United States Patent and Trademark Office

APPLICATION NO.	FILING DATE	FIRST NAMED INVENTOR	ATTORNEY DOCKET NO.	CONFIRMATION NO.
10/809,902	03/26/2004	Makoto Miyamoto	YMOR:197A	7694
27890 7	590 01/18/2006		EXAM	INER
	JOHNSON LLP		WATKO, JULIE ANNE	
1330 CONNECTICUT AVENUE, N.W. WASHINGTON, DC 20036		•		
		,	ART UNIT	PAPER NUMBER
			2653

Application No.	Applicant(s)				
	10/809,902	MIYAMOTO ET AL.				
Office Action Summary	Examiner	Art Unit				
	Julie Anne Watko	2653				
The MAILING DATE of this communication appears on the cover sheet with the correspondence address Period for Reply						
A SHORTENED STATUTORY PERIOD FOR REPLY IS SET TO EXPIRE 3 MONTH(S) OR THIRTY (30) DAYS, WHICHEVER IS LONGER, FROM THE MAILING DATE OF THIS COMMUNICATION. - Extensions of time may be available under the provisions of 37 CFR 1.136(a). In no event, however, may a reply be timely filed after SIX (6) MONTHS from the mailing date of this communication. - If NO period for reply is specified above, the maximum statutory period will apply and will expire SIX (6) MONTHS from the mailing date of this communication. - Failure to reply within the set or extended period for reply will, by statute, cause the ap

Campbell et al Fig. 5, annotated

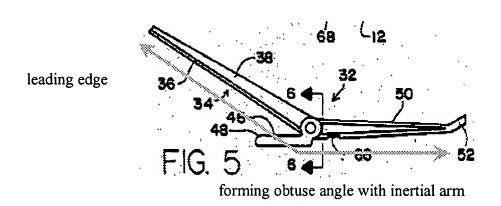
On page 11, 1st paragraph, Applicant argues that "Campbell, in contrast to the presently claimed invention, discloses that the leading edge of the aerodynamic latch member 32 is straight, as illustrated in Campbell's Fig. 1. Thus, Campbell does not teach or suggest a 'wind receiver that receives said force of air flow has a leading edge that forms an obtuse angle with said inertial arm." The Examiner has considered this argument thoroughly and agrees that the leading edge 36 of the wind receiver 34 is straight; however, said straight edge 36 forms an

obtuse angle with the latching portion 50 of inertial arm 32 (see Fig. 5, which shows an angle between 36 and 50 which is quite clearly obtuse).

Furthermore, a change in shape would not give rise to patentability, absent evidence of unexpected results due to the claimed shape. *In re Dailey*, 357 F.2d 669, 149 USPQ 47 (CCPA 1966).
